# MDI Considerations for 802.3db Comment against Draft 0.1

IEEE P802.3db 100 Gb/s, 200 Gb/s, and 400 Gb/s Short Reach Fiber Task Force

01 April 2021 Teleconference Ad Hoc Meeting

Figure 167-6—Optical lane assignments for 200GBASE-VR2 or 200GBASE-SR2

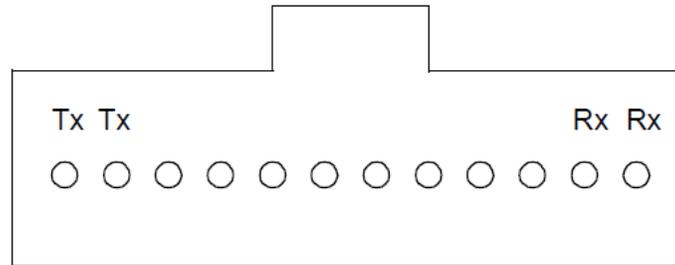
# Optical lane assignments for 200GBASE-VR2 and 200GBASE-SR2

- Same as in Clause 138 for 100G-SR2

Figure 167-7—Optical lane assignments for 400GBASE-VR4 or 400GBASE-SR4

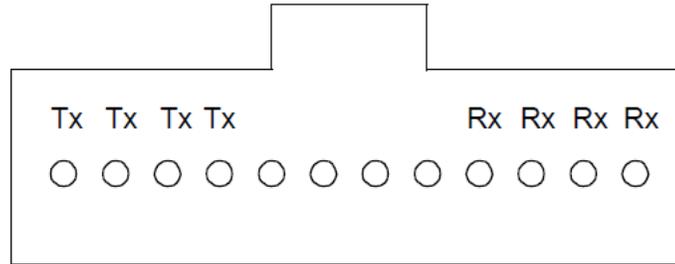
# Optical lane assignments for 400GBASE-VR4 and 400GBASE-SR4

- Same as in Clause 138 for 200G-SR4
